## **SENIORS LIVING DEVELOPMENT AND DEMOLITION OF EXISTING DWELLINGS AT NOS. 461-473 PACIFIC HIGHWAY, ASQUITH (PANEL REF: PPS- 2018SNH033)**

This letter has been prepared by Urbis on behalf of Chinese Australian Services Society Limited (CASS) (the applicant) to provide additional information to assist the North Sydney Planning Panel (the panel) in determining PPS-2018SNH033 (the proposal).

Figure 2 Proposed Vertical Clearance – Section

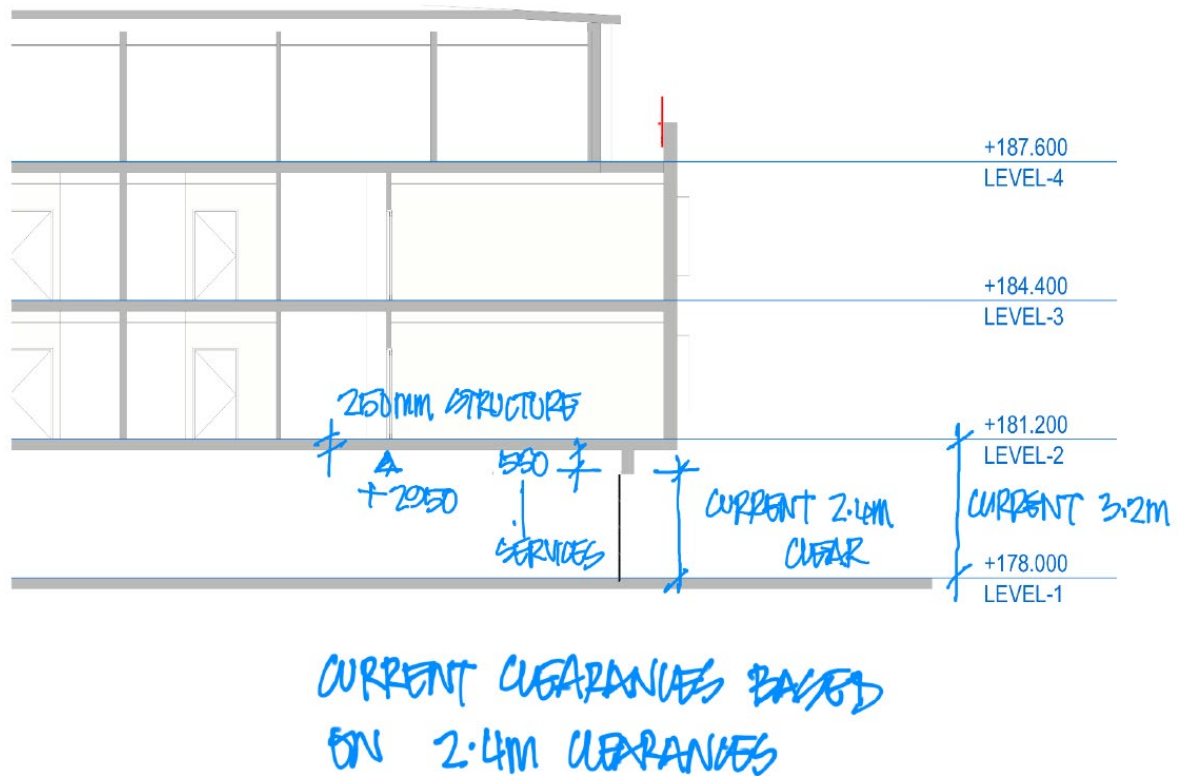
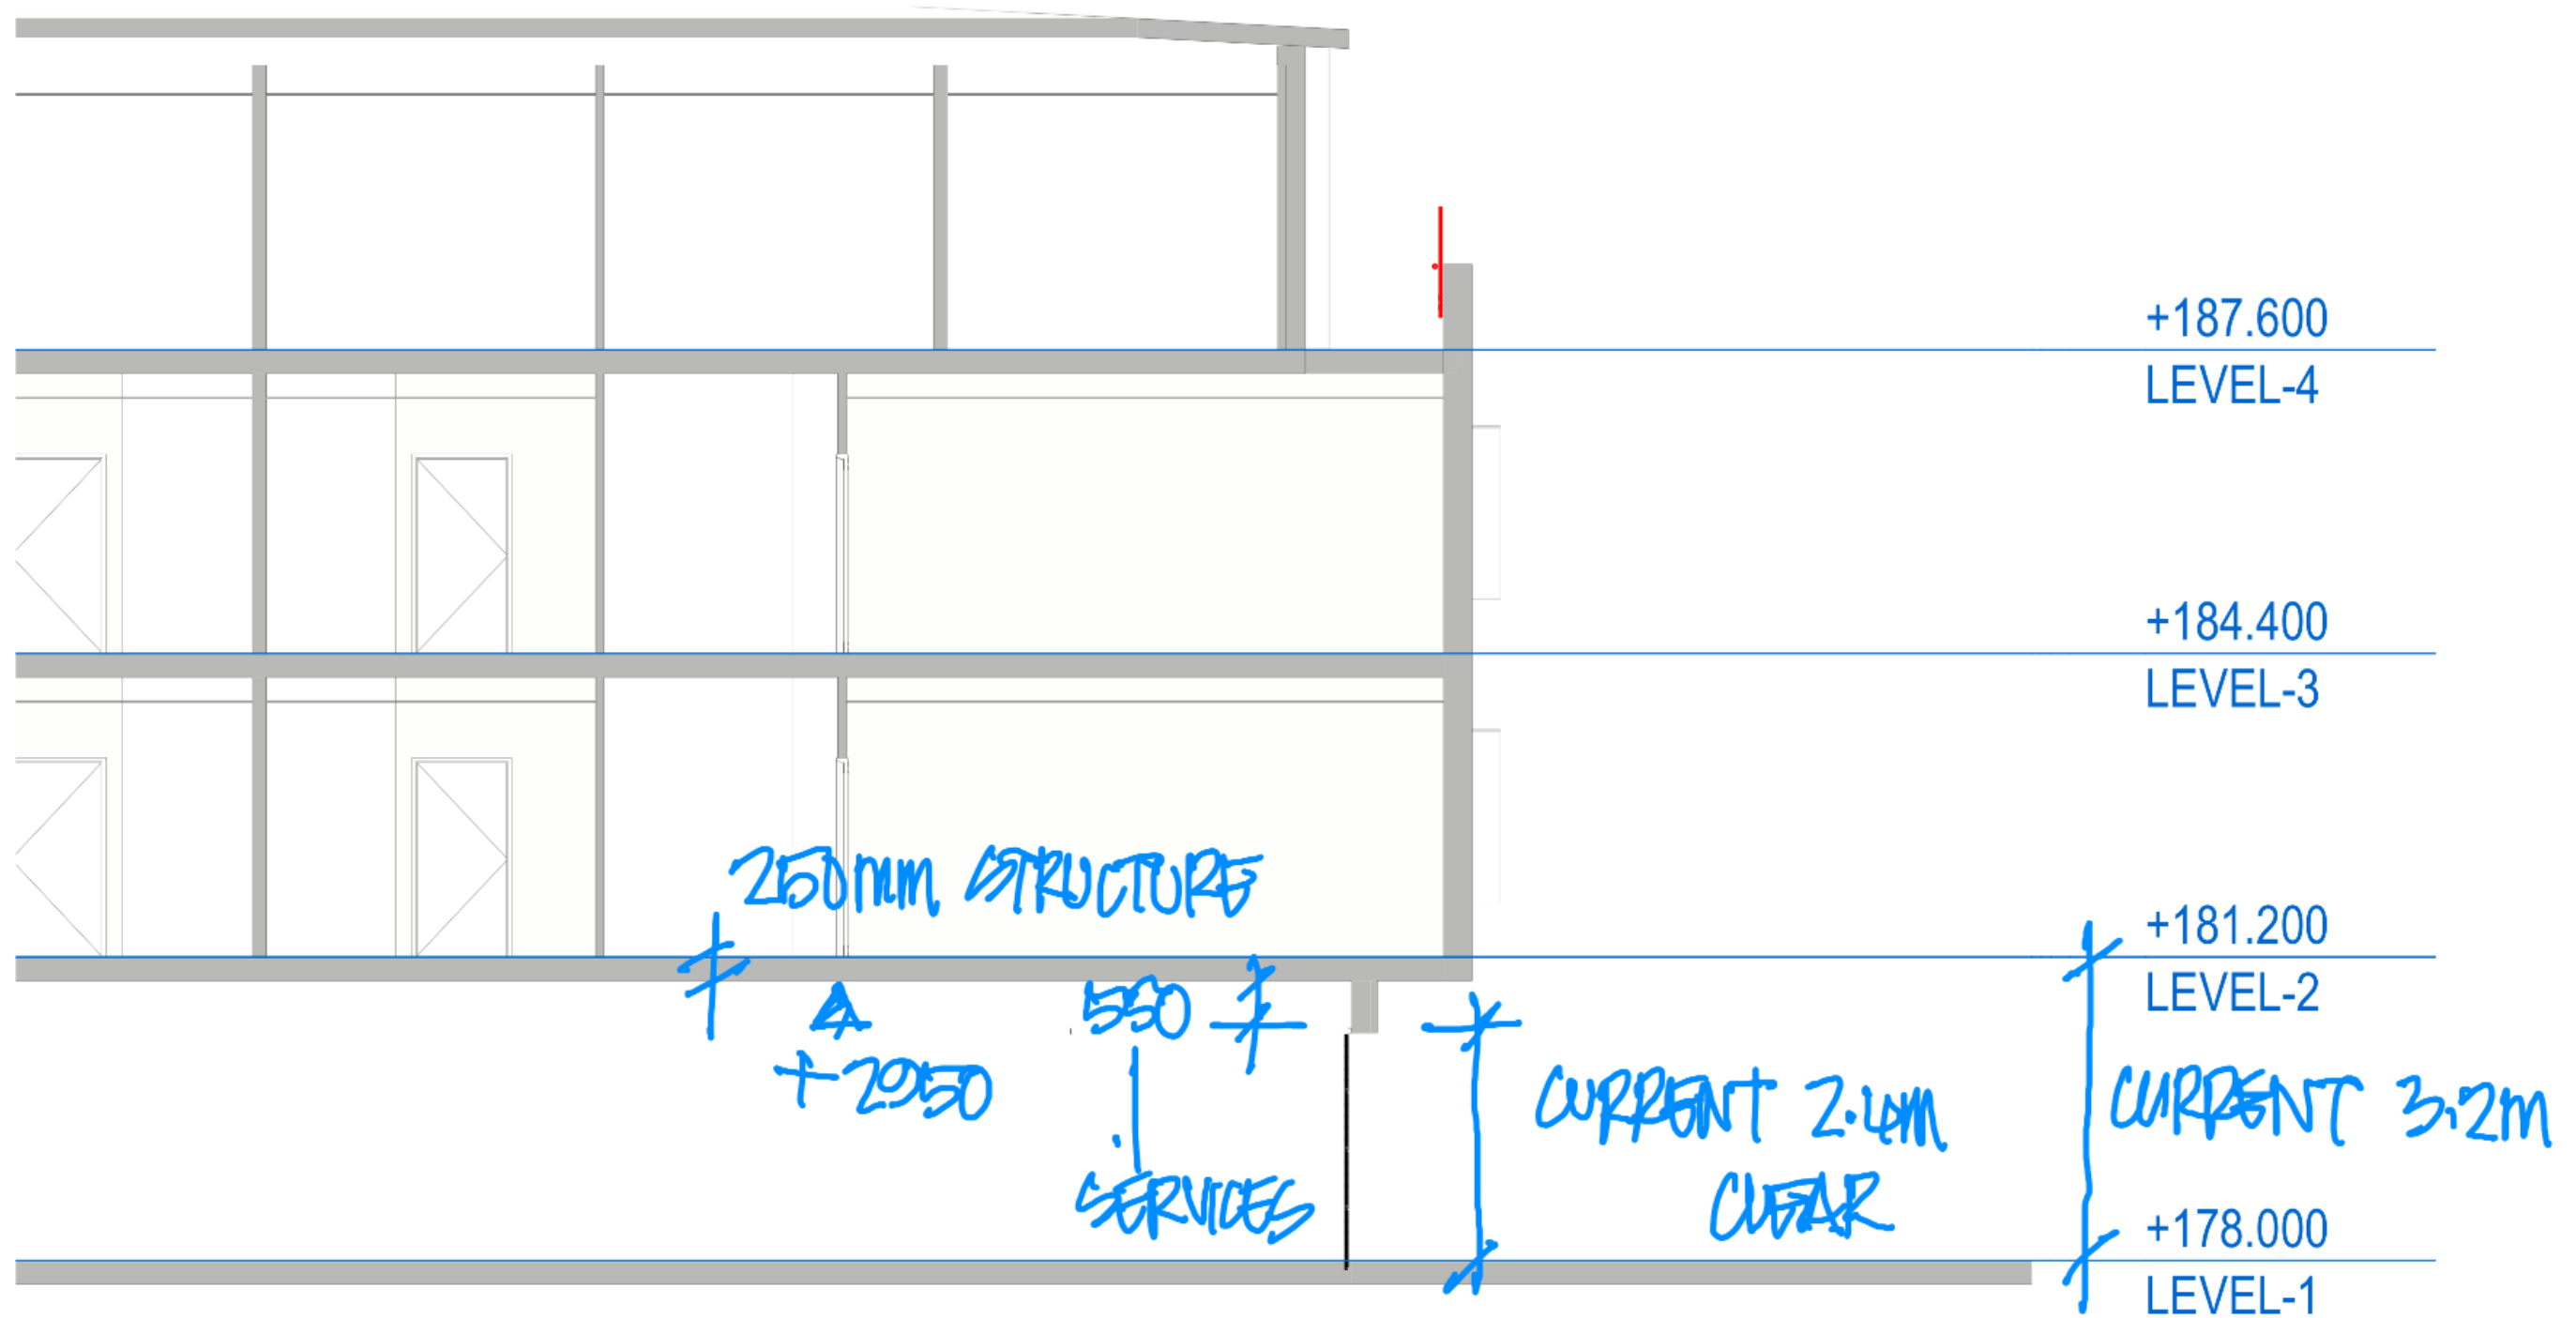
A clearance height of 2.4m is proposed to the basement, which is approximately 1.1m lower than that required by Council. A 3.5m basement clearance is not required in this instance as waste collection for the RACF will be undertaken from within the basement car park (Level 1) using a waste wise mini rear loader operated by a private management contractor.

Operationally, the 2.4m clearance height provides sufficient vertical clearance to accommodate the private contractor waste vehicle and delivery vehicles to the site. The project architect has confirmed that the 2.4m vertical clearance includes provision for 0.55m of ceiling mounted objects, and any floor mounted objects required (refer **Figure 2** and **Attachment B2**). The applicant submits that Condition 85(h) (Waste Management Details) as drafted by Council ensure that the vertical clearance accounts for ceiling mounted objects.

### Attachment B3 - Extent of basement required to be raised to accommodate 3.5m vertical clearance

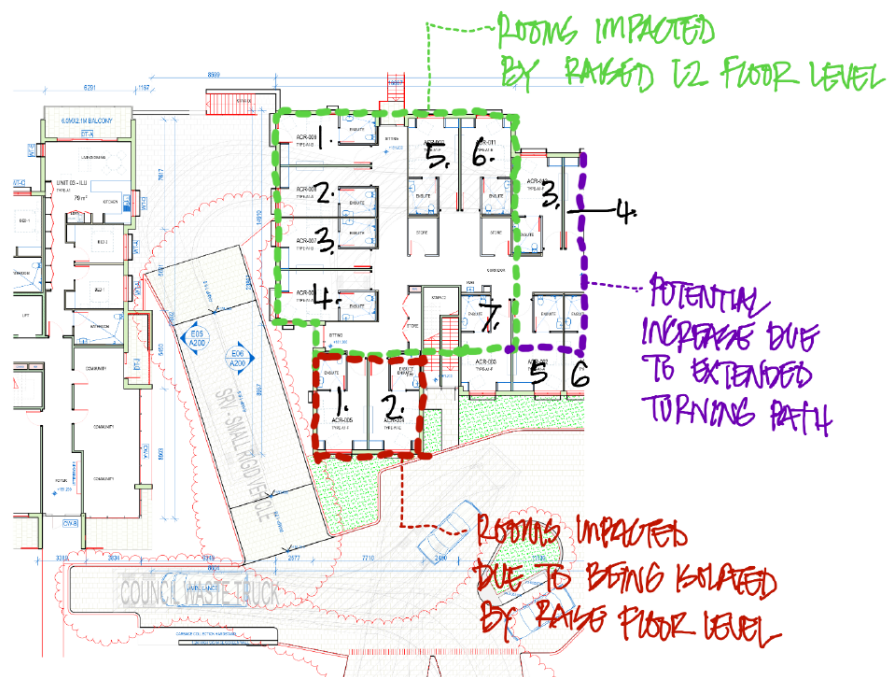
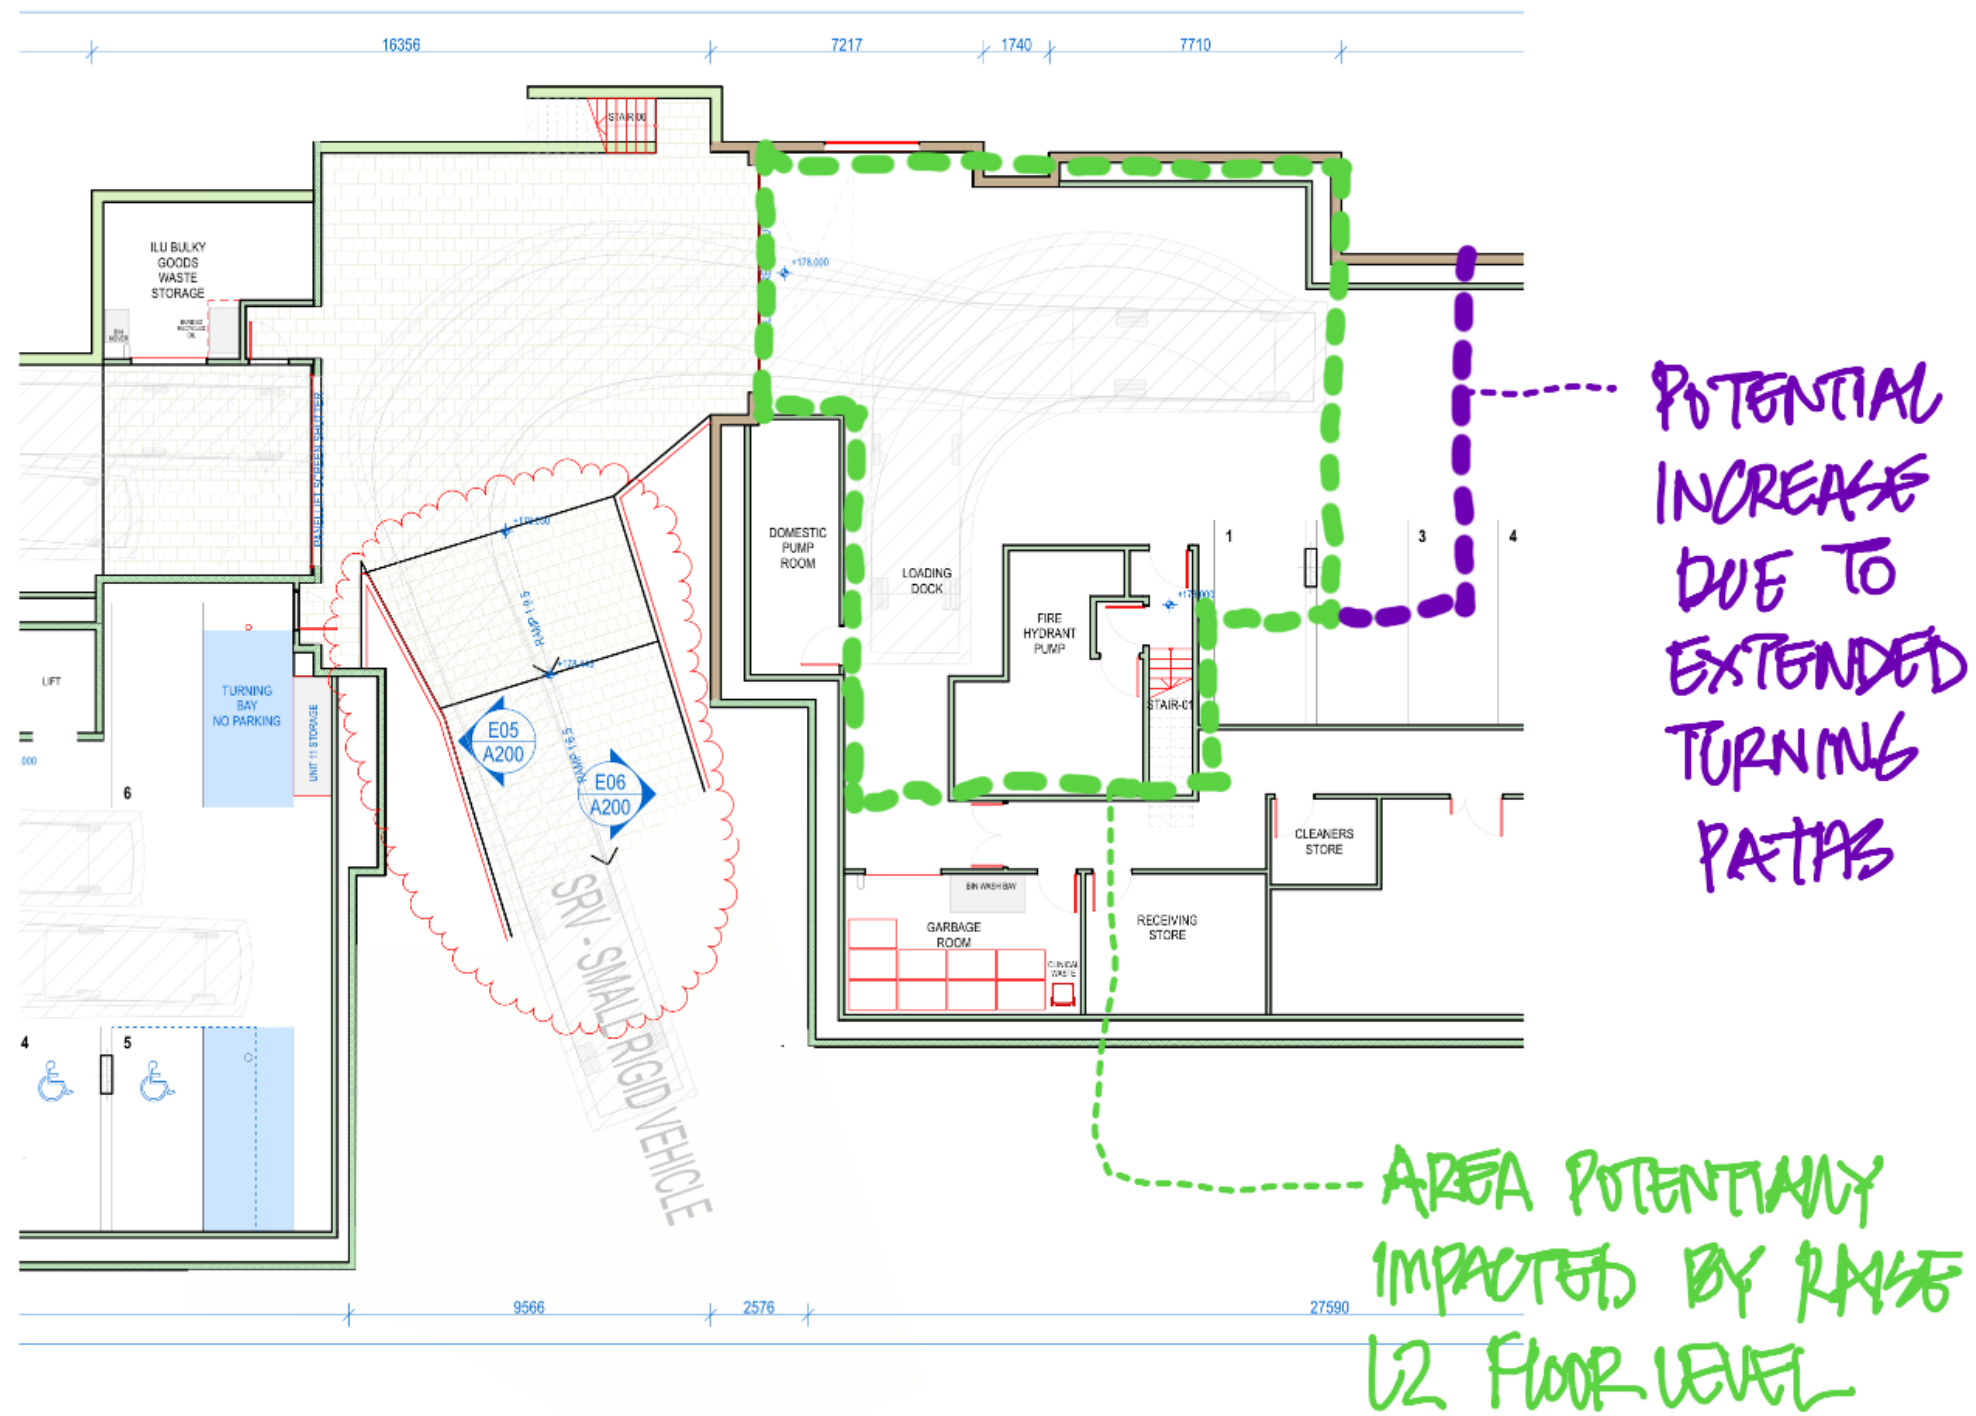
The project architect has diagrammatically reviewed the impacts to the yield of the development should a 3.5m basement clearance be accommodated (refer **Figure 3 – Attachment B3** and **Figure 4 Attachment B4**).

Council submit that only two bedrooms will require deletion to accommodate the increased basement clearance, being ACR-008 and ACR- 009, which are the two bedrooms located directly above the basement entrance.

As demonstrated in **Figure 3 – Attachment B3** Council have failed to recognise the swept path of the waste collection vehicle which will increase the extent of the impacts to the RACF bedrooms located directly above the basement entrance.
